STATE OF NORTH CAROLINA
DEPARTMENT OF TRANSPORTATION

SUBJECT: **Request for Modification of the Section 404 Individual Permit, Section 401 Water Quality Certification, Isolated Waters State General Permit, and Neuse River Riparian Buffer Certification** for the proposed East End Connector from NC 147 (Durham Freeway/Buck Dean Expressway) to north of NC 98 (Holloway Street) in Durham, Durham County, North Carolina, Division 5. Federal Aid Project No. NHF-76-1(2), TIP No. U-0071.

In addition to this cover letter, please find enclosed Wetland Permit Drawing Sheet Number 4 and Wetland Permit Impact Summary Sheet; Buffer Permit Drawing Sheet No 4 and the Buffer Impacts Summary Sheet, a NCDWR Stream Form, and a NCSAM Field Assessment.

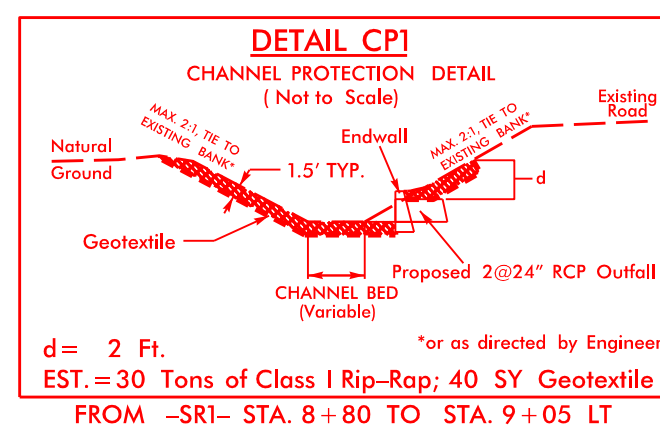
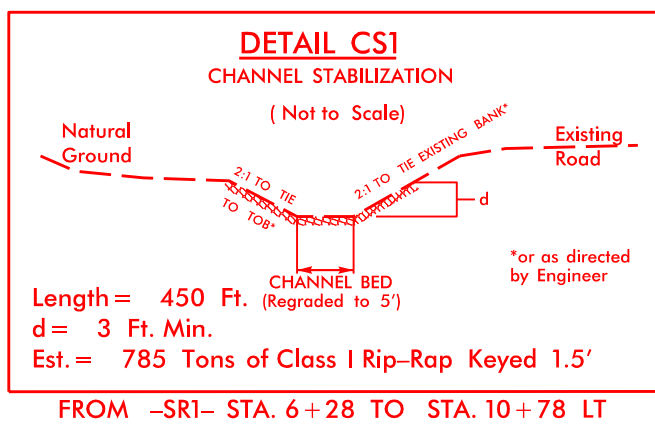
A recent plan revision changed the installation of a sanitary sewer line and drainage system in the area of SZZ. The City of Durham indicated that the new drainage structures (2 @ 24 inch reinforced concrete pipes) that discharge into the jurisdictional feature could not be placed above the sewer line and would have to be installed below the sewer line. The recent installation of the 2 @ 24 inch reinforced concrete pipes revealed that the inverts of the structures are significantly below the adjacent elevation of the perennial stream. Invert elevations of the pipe structures were evaluated and could not be changed. The only practical option was to regrade the stream channel in a slightly lower elevation and place the feature in a Class I rip rap lined channel (see Details CS1 and CP1) from 6+28 to 10+78 Lt -SR1- on Permit Sheet 4.

NOTES:
Wetland impact sheet only for permanant surface water impacts along SR1 on Parcel 1
Channel to be regraded to maintain postive drainage from 36" RCP outlet at SR1 10+78 (34.5' LT)
to 48" RCP under driveway on Parcel 1 at SR1 6+28 (45.5'. LT)

NOTES:
 Buffer impact sheet only for parallel impacts along SR1 on Parcel 1
 Channel to be regraded to maintain positive drainage from 36" RCP outlet at SR1 10+78 (34.5' LT)
 to 48" RCP under driveway on Parcel 1 at SR1 6+28 (45.5' LT)
